FINAL PLAT FOR
ARROYO RANCH PHASE VII
CITY OF SEGUIN, GUADALUPE COUNTY, TEXAS
BEING 11.65 ACRES OUT OF THE MANSOLO A. SURVEY,
ABSTRACT NO. A-29, CITY OF SEGUIN, GUADALUPE
COUNTY, TEXAS.

OVERALL LAYOUT
ARROYO RANCH PHASE VII
CITY OF SEGUIN, GUADALUPE COUNTY, TEXAS

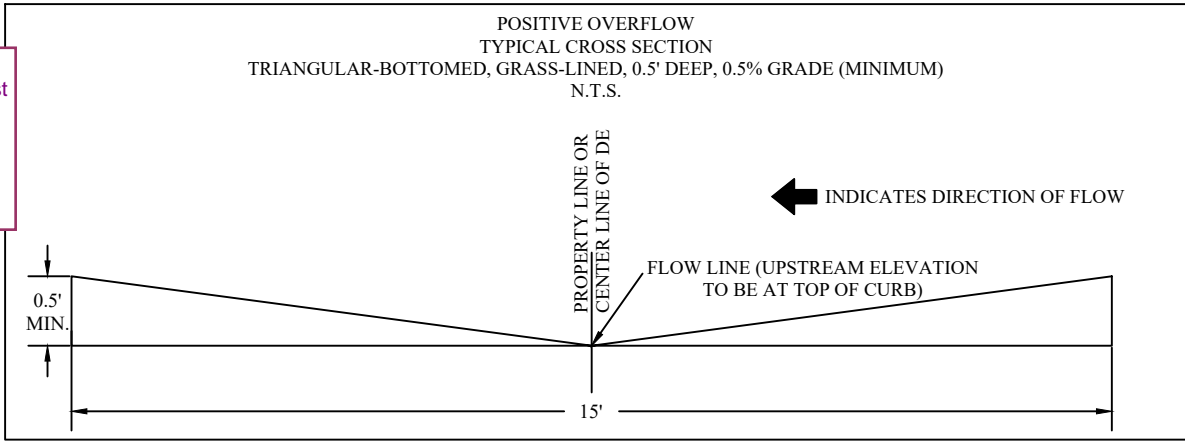
What is the purpose of this detail?
There is no general condition note in the above list which creates a covenant on this plat for a side yard drainage channel requirement between lots.
It is not specific to land entitlement and is it warranted on a Subdivision Plat?

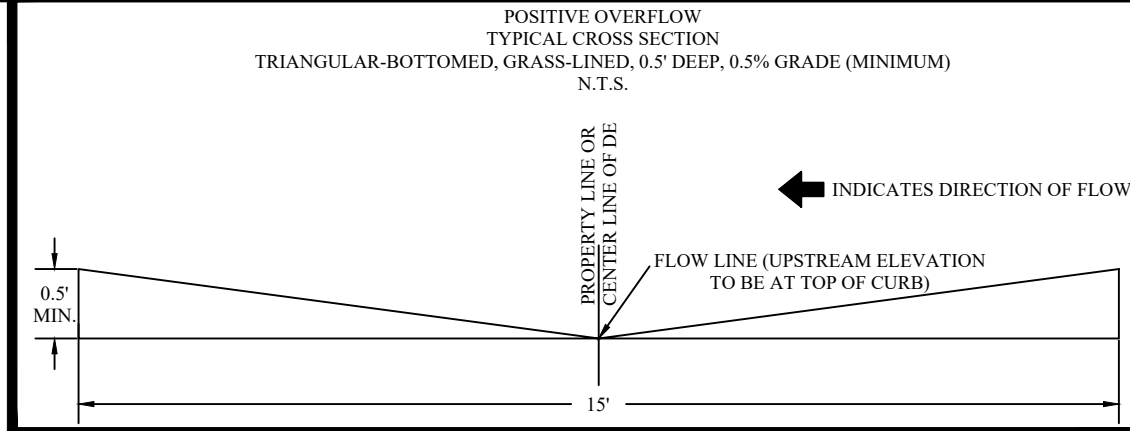
Detail does not match over GVEC standards recorded in there service area in 2023/24.

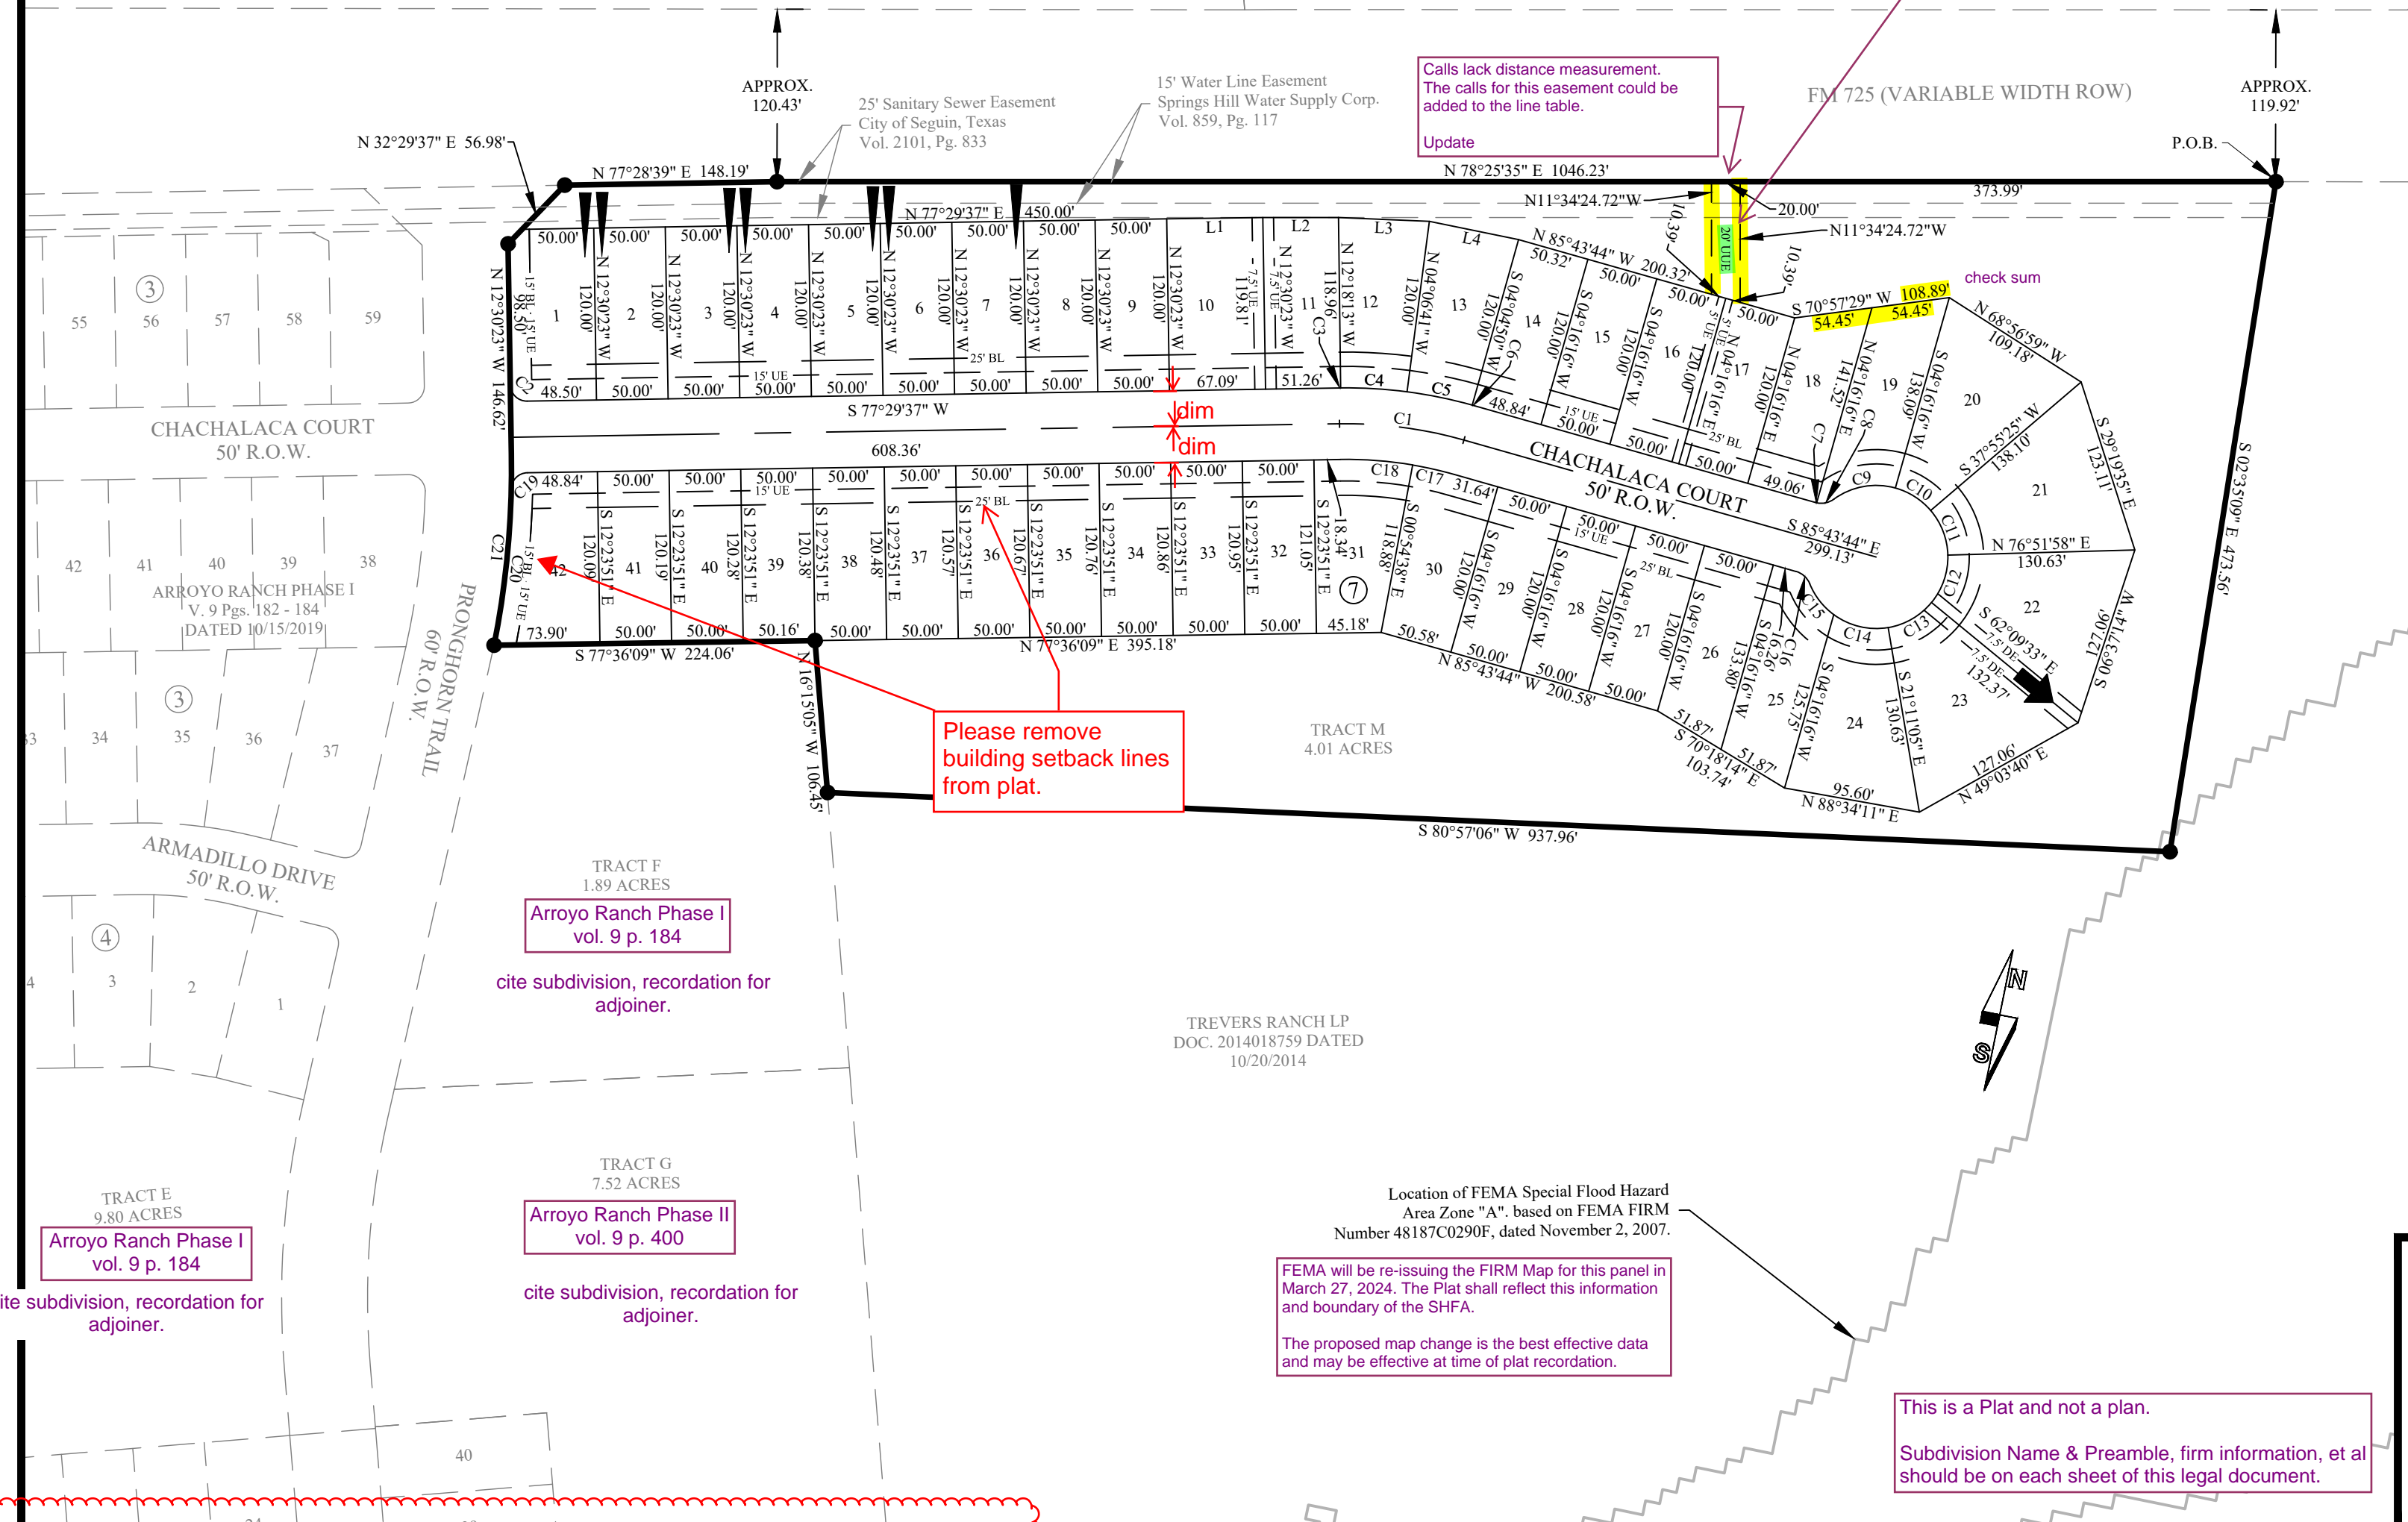
Add "Public"
i.e. Public Utility Easement
